METROPOLITAN GOVERNMENT OF NASHVILLE AND DAVIDSON COUNTY

STAFF RECOMMENDATION
800 Setliff Place
July 15, 2015

Application: New construction--addition
District: Eastwood Neighborhood Conservation Zoning Overlay
Council District: 06
Map and Parcel Number: 08306005800
Applicant: Paul John Boulifard
Project Lead: Paul Hoffman, paul.hoffman@nashville.gov

<p>Description of Project: An application for a ridge raise and addition to the rear and side of the house.</p> <p>Recommendation Summary: Staff recommends approval with the conditions:</p> <ol style="list-style-type: none"> 1. Staff approve the final details, dimensions and materials of windows and doors prior to purchase and installation; 2. HVAC and other utilities should be located so as to minimize visibility from the street-facing facades; and, 3. Staff approve the roof color and masonry color, dimensions and texture. <p>Staff finds the project meets the design guidelines for the Eastwood Neighborhood Conservation Zoning Overlay.</p> <p>The Commission does not have the authority to approve the use. This recommendation is for the design of the building based on the proposed use.</p>	<p>Attachments A: Photographs B: Site Plan C:

① SIDE ELEVATION - 1 PROPOSED
1/8" = 1'-0"

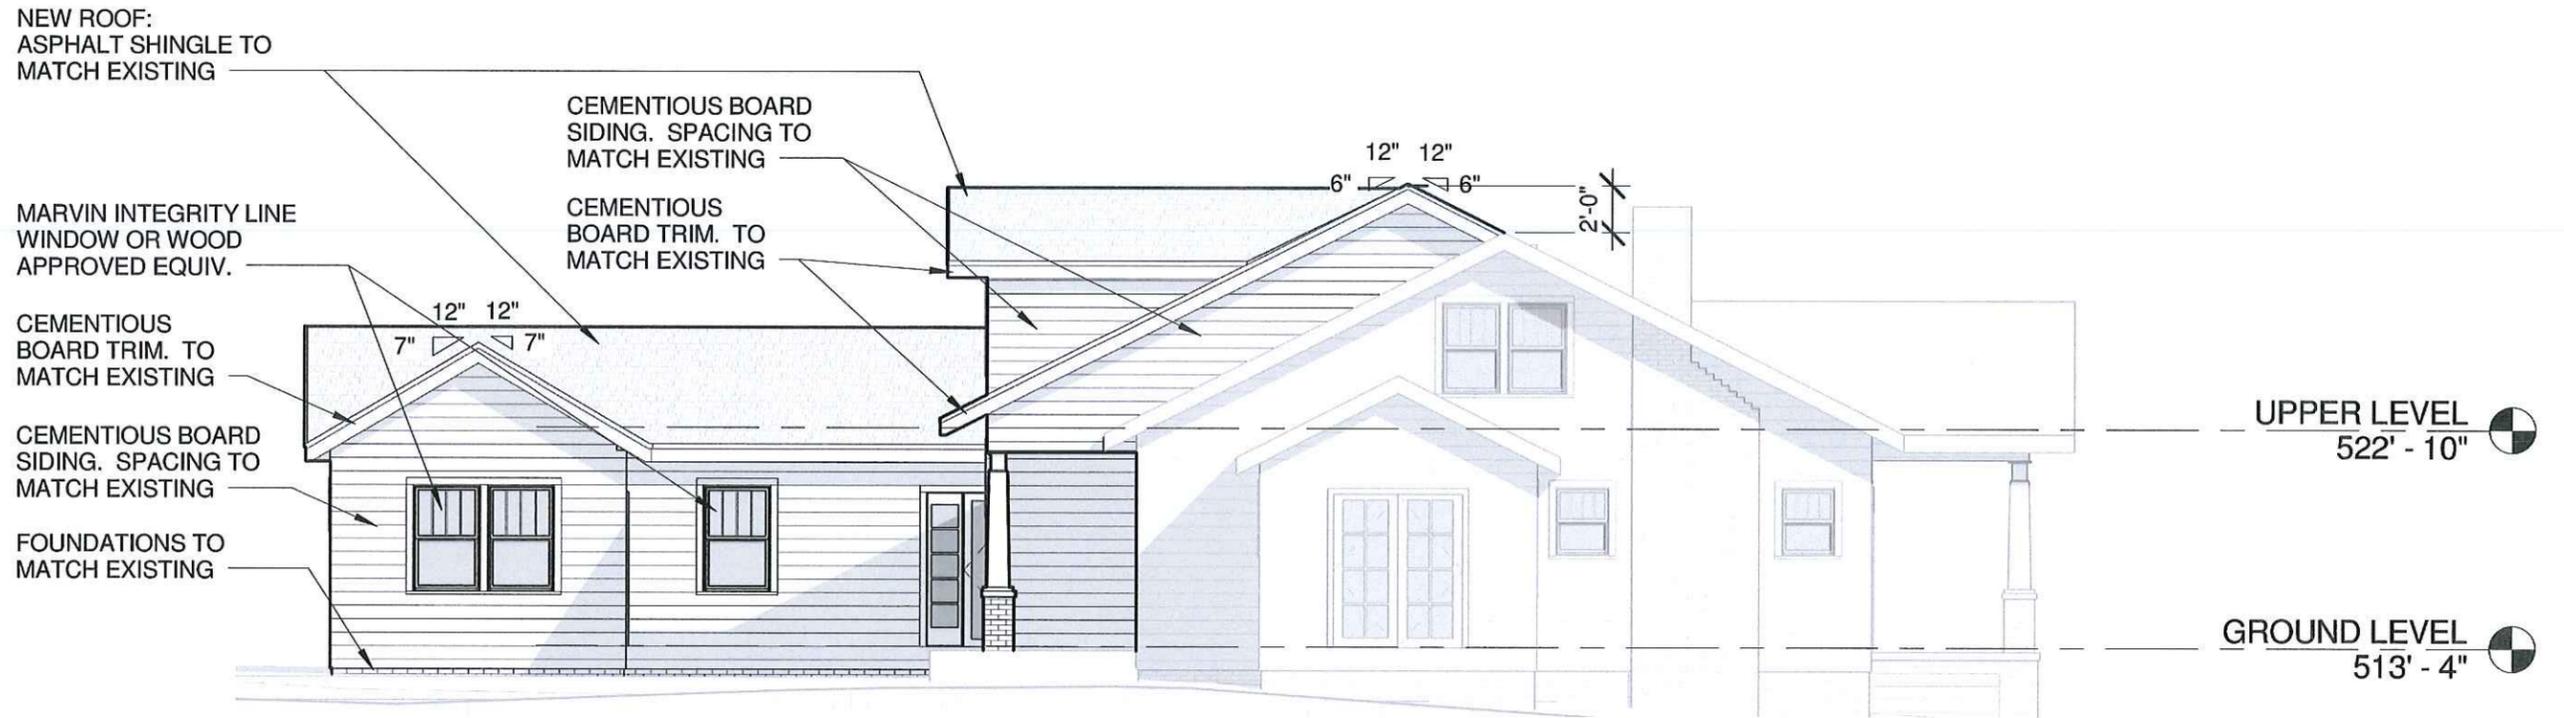
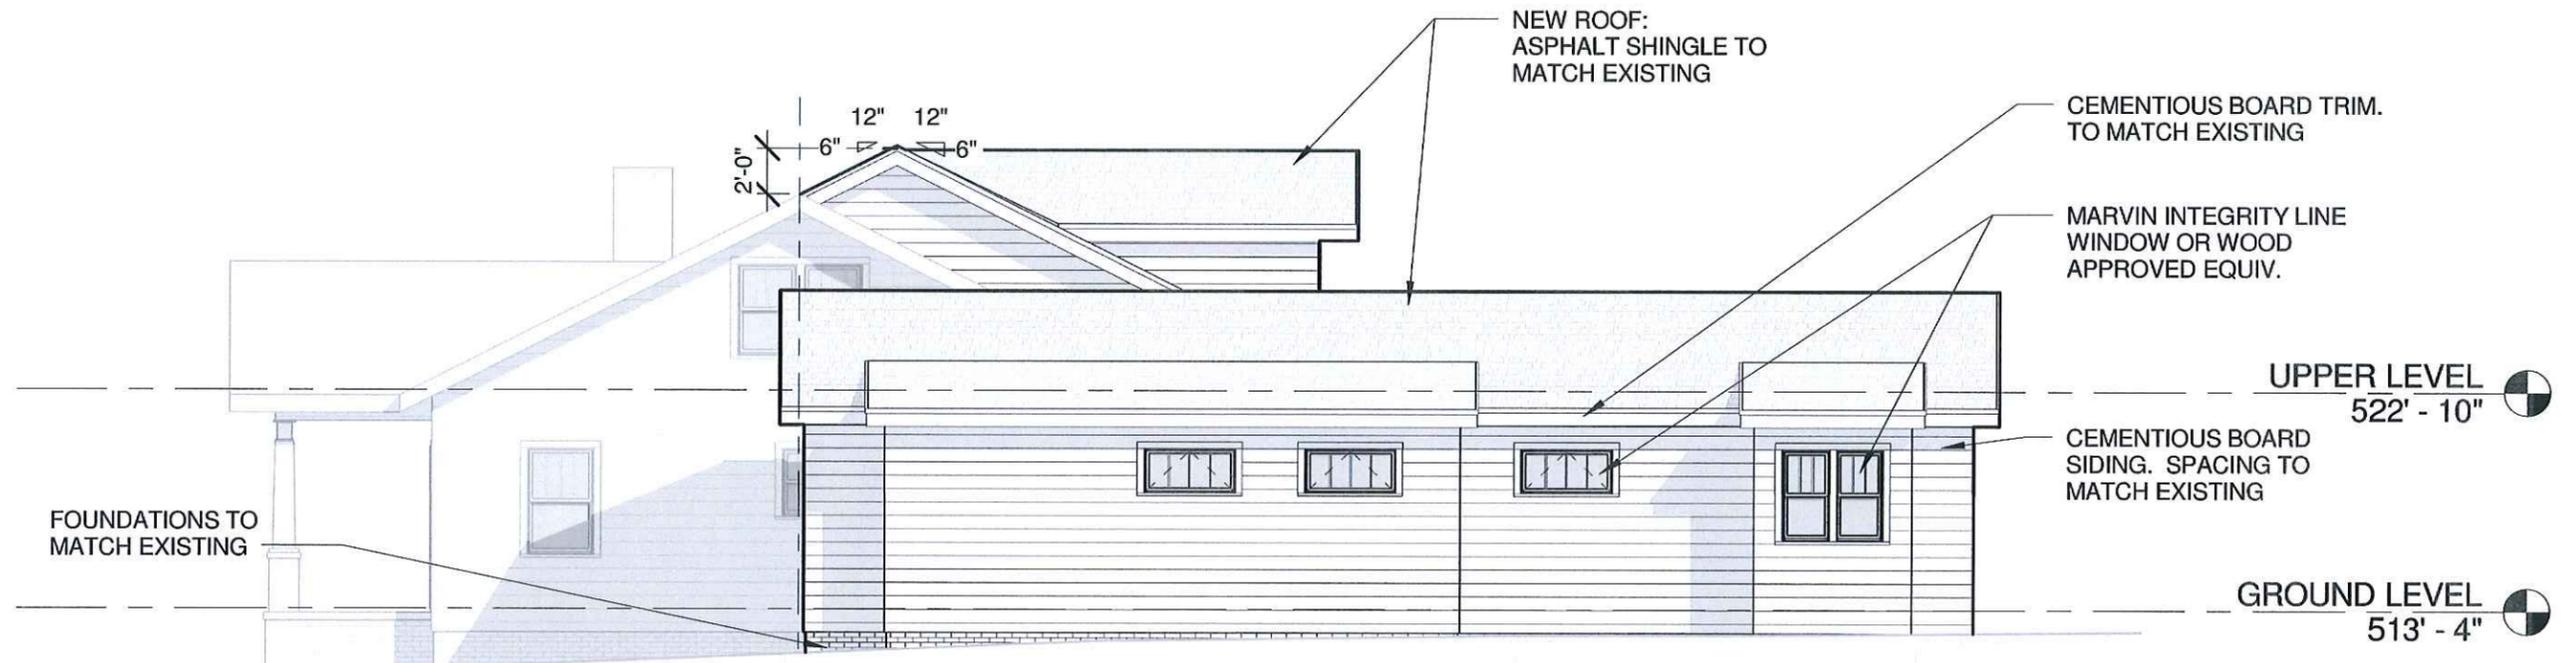
Proportion and Rhythm of Openings: Most of the proposed new windows meet the historic proportion of openings. There are horizontal windows on both the side and rear of the addition. The Commission has recently approved these transom-style windows provided they are located past the midpoint of the house, which these are. The largest expanse of wall space without a window or door opening is eleven feet (11') on the right side of the addition. Staff finds the project's proportion and rhythm of openings to meet Section II.B.1.g.

1. Staff approve the final details, dimensions and materials of windows and doors prior to purchase and installation;
2. HVAC units and other utilities should be located to minimize their visibility from the street; and,
3. Staff approve the roof color and masonry color, dimensions and texture.
